Seating and Concession

Haslock Stadium

1. WILL THERE BE SPACE TO MAINTAIN THE SEWER MANHOLE BY THE SEAT EXPANSION? PLEASE EXPLAIN.
2. HOW ARE THE SEATS GOING TO FIT IN WITH THE SCOREBOARD SIGN POST?
3. TIE IN STORMWATER NEAR THE PROPOSED CONCESSION STAND TO THE INFILTRATION DRAIN UNDER THE COVERED PICNIC AREA.
4. THE ^{NEW} CONCESSION STAND BUILDING - WHAT SHAPE IS THE ROOF? DEPENDING ON THE SHAPE OF THE ROOF, IT WILL AFFECT WHERE THE STORMWATER LANDS, WHERE IS THE STORMWATER INTENDED TO GO?
5. CLARIFY THE LOCATION AND IMPROVEMENTS OF THE REMAINING SERVICE DRIVEWAY.

The following correspondence is in regards to staff comments that you and Jim Seymour provide to us on November 19th, concerning the proposed improvements at Hadlock Stadium. We have revised the plans and prepared the following responses to address those comments:

HADLOCK STADIUM EXPANSION
TREE RELOCATION SKETCH

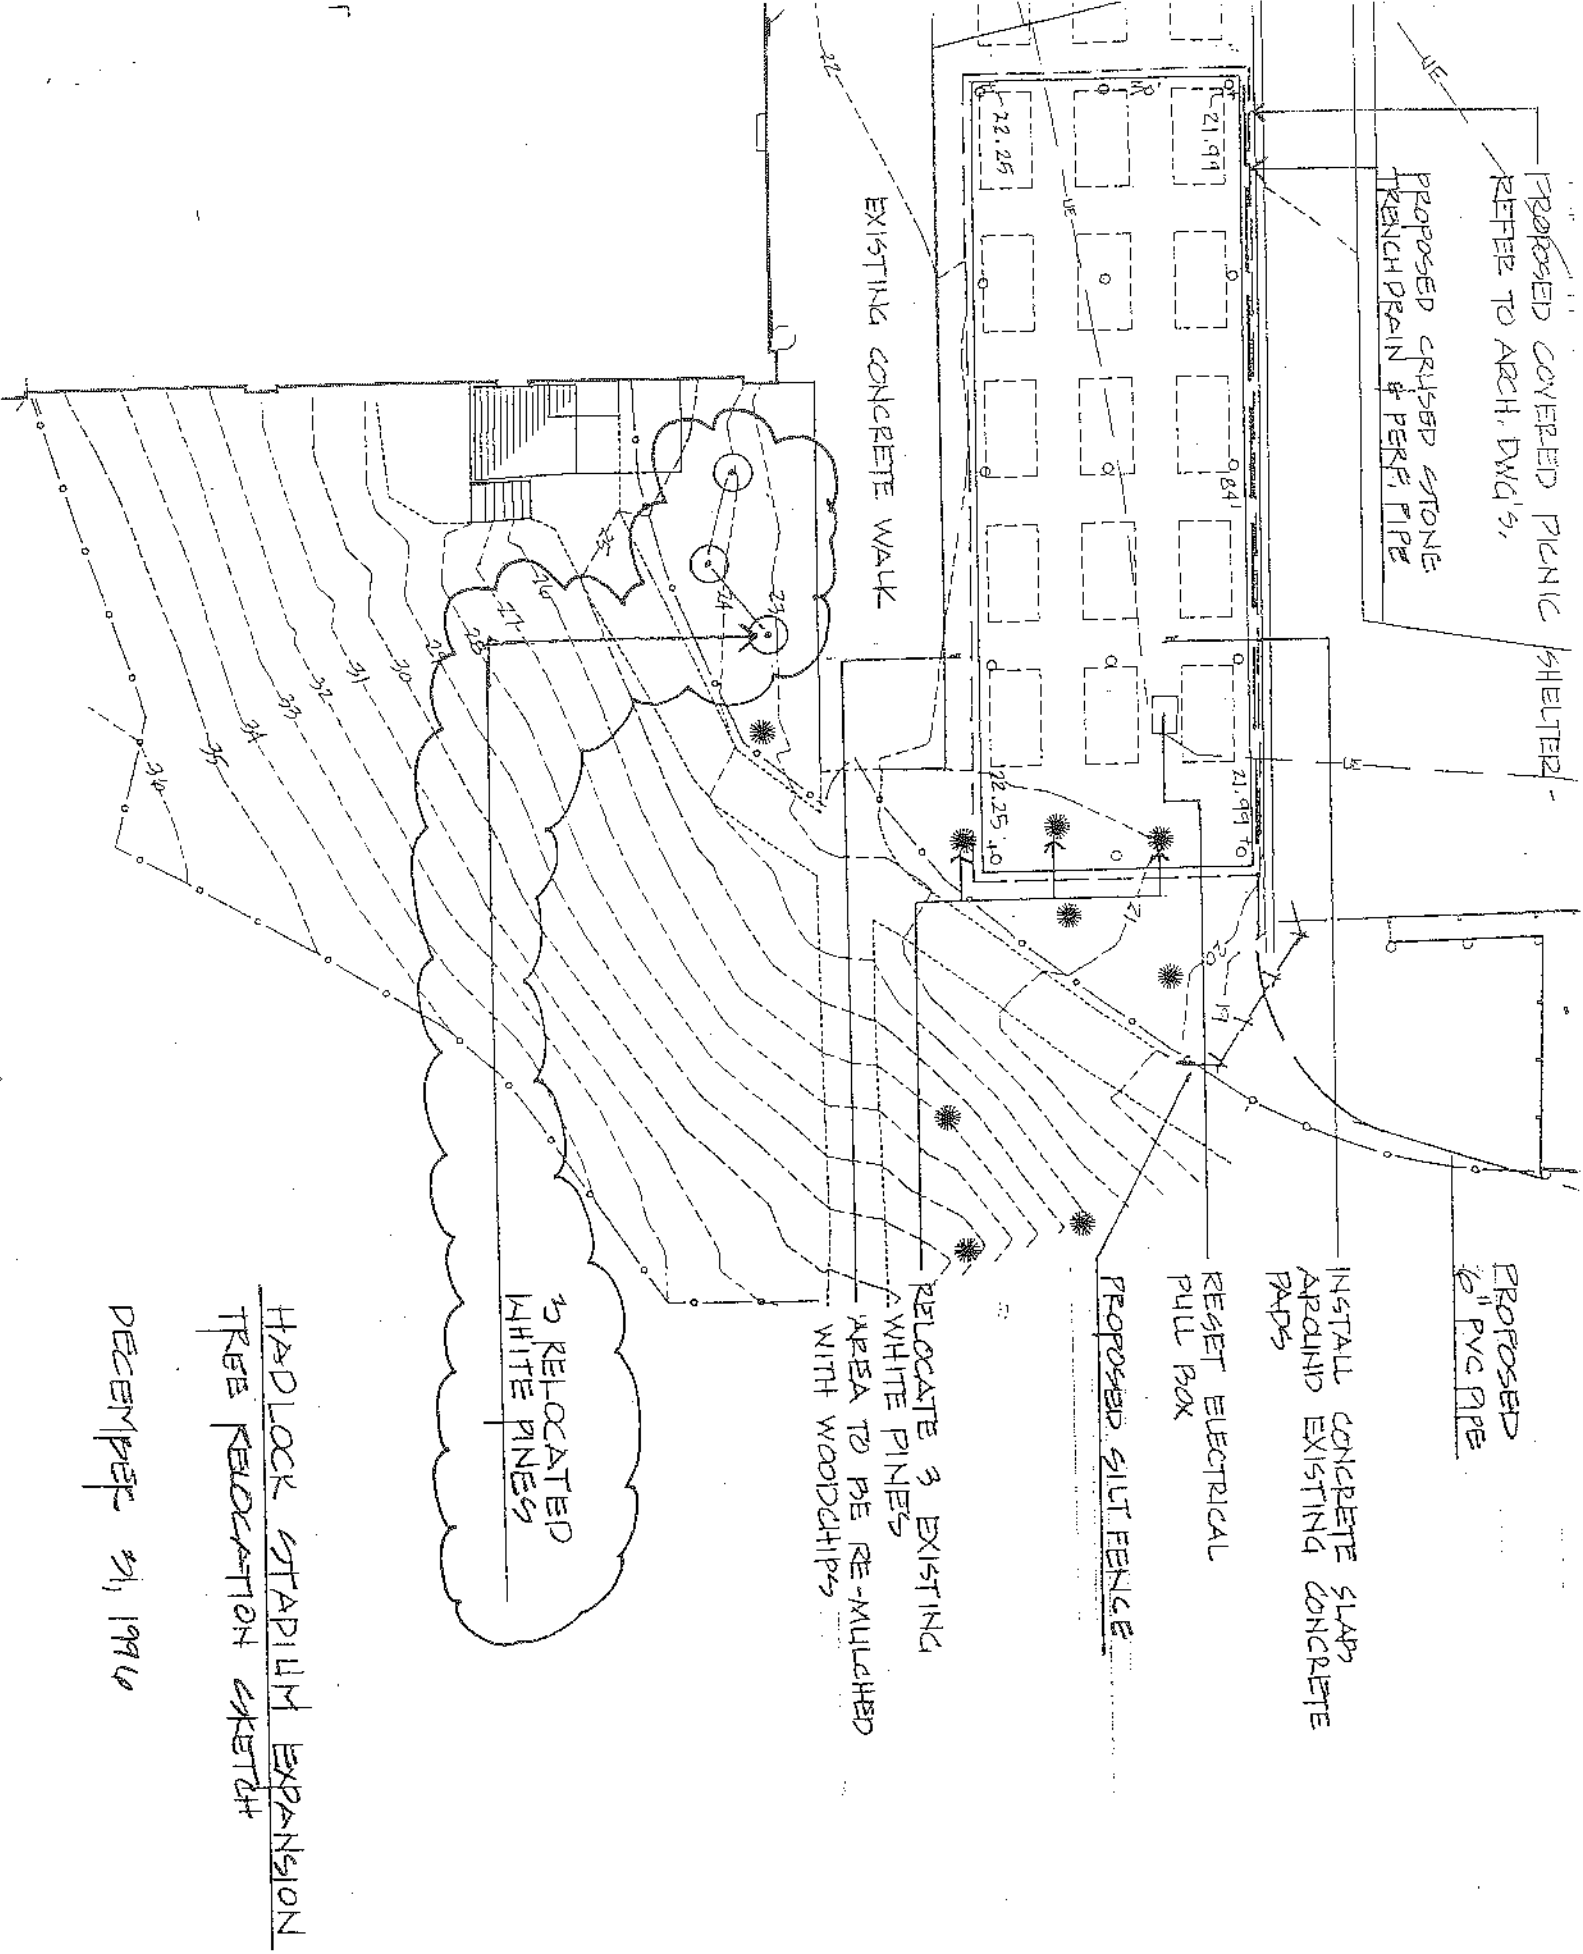
6. **Staff also questioned the status of existing vegetation along the present picnic area seating and where it would be relocated.**

As agreed to, we have placed a note on the Site Plan indicating that when the picnic area seating project is scheduled for construction, the existing vegetation requiring removal will be relocated to a location on the sports complex as determined by the City Arborist.

SECTION THRU RETAINING WALL
 NOT TO SCALE

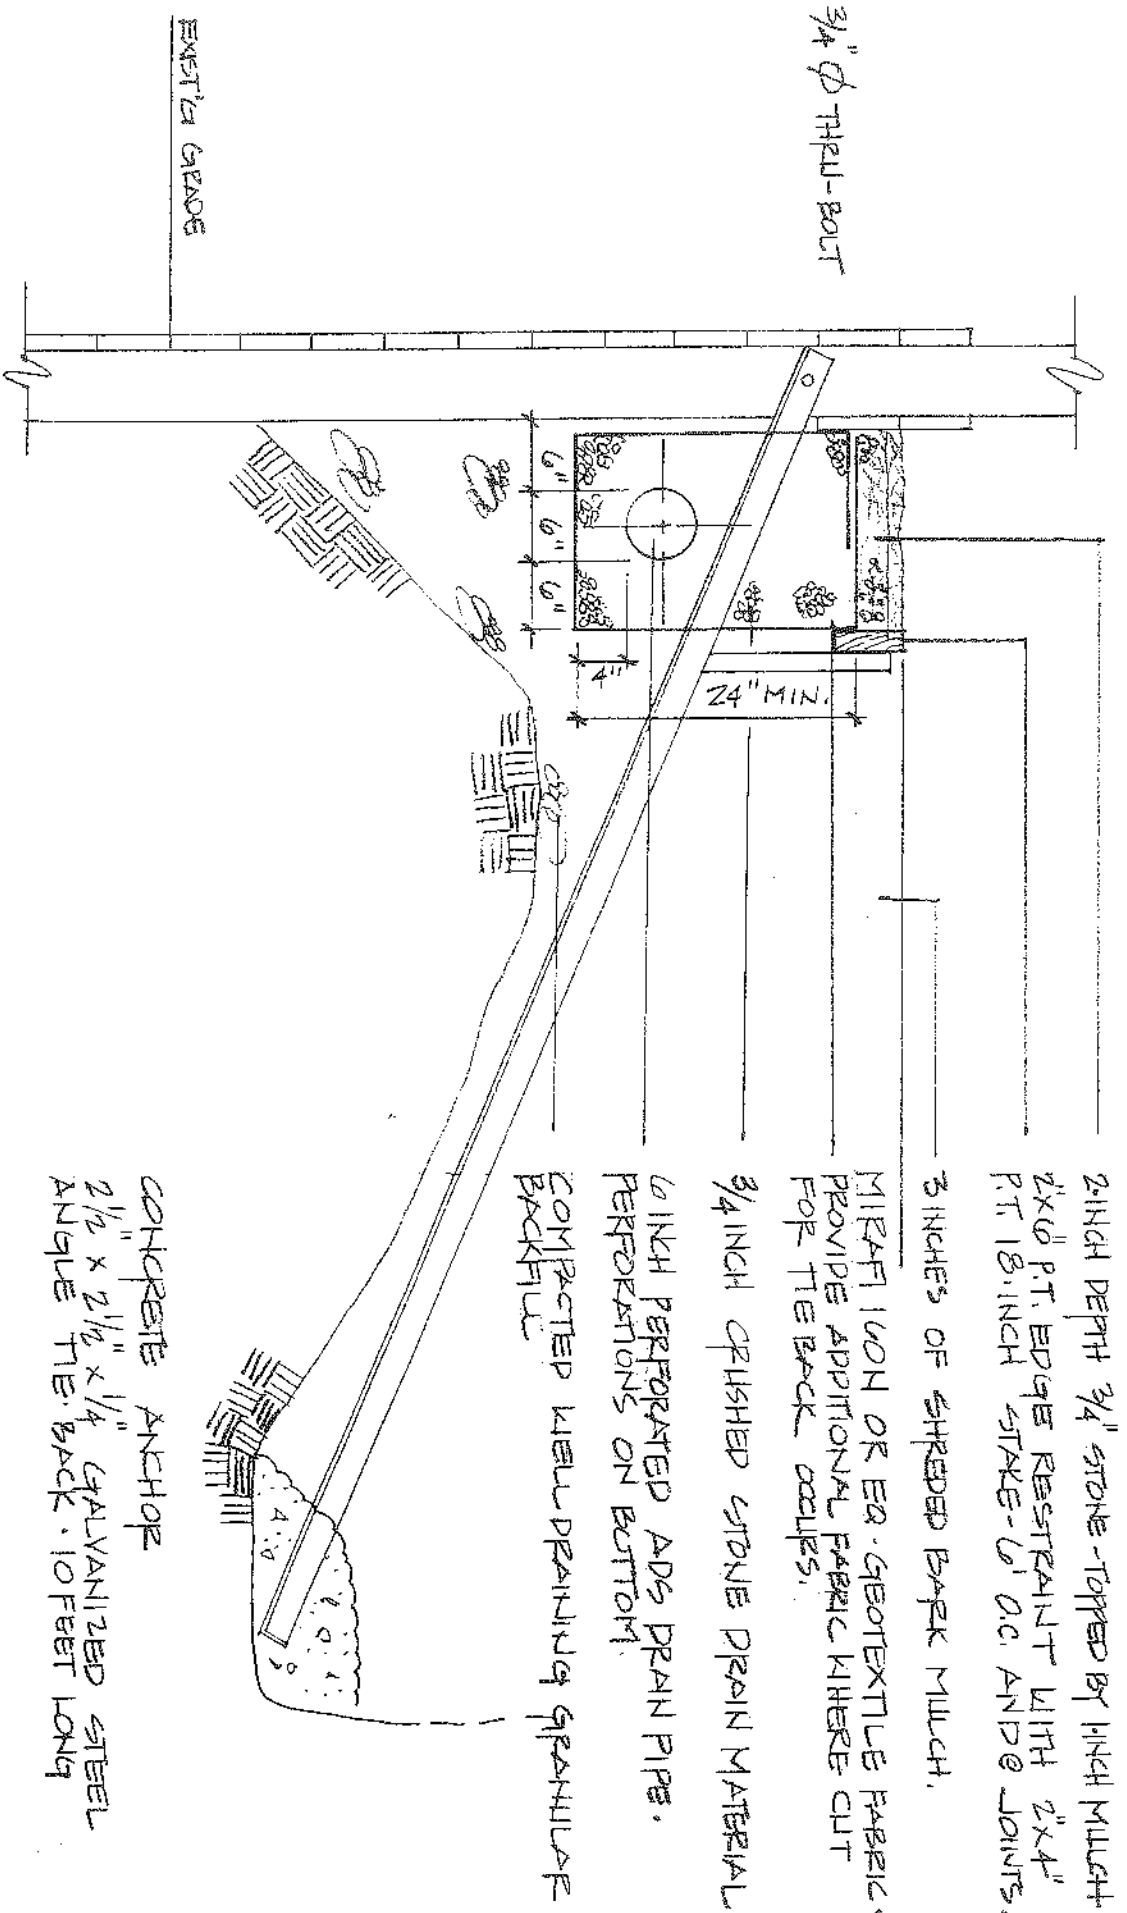
- Jim Seymour also recommended that we install an under-drain behind the proposed retaining wall associated with the concession building. A perimeter under-drain has been added to the backside of the retaining wall to relieve potential hydrostatic pressure and freeze thaw impacts on the wall. The under-drain will be connected to the proposed stone drip edge drain system.

At your request we have prepared a series of sketches and details to construct the extension of the retaining wall at Hadlock Stadium for your review. As we discussed, I spoke with Rick Knowland, Senior Planner in the City Planning Department concerning these improvements. Rick indicated they would require staff review, however he did not see this being a major issue or time requirement. Please review these sketches and comment on any changes you may wish to make. Once you have approved the plans we can submit them to the Planning Department for staff review. Upon staff approval you may proceed with the improvements. Should you have any questions, please do not hesitate to call me.
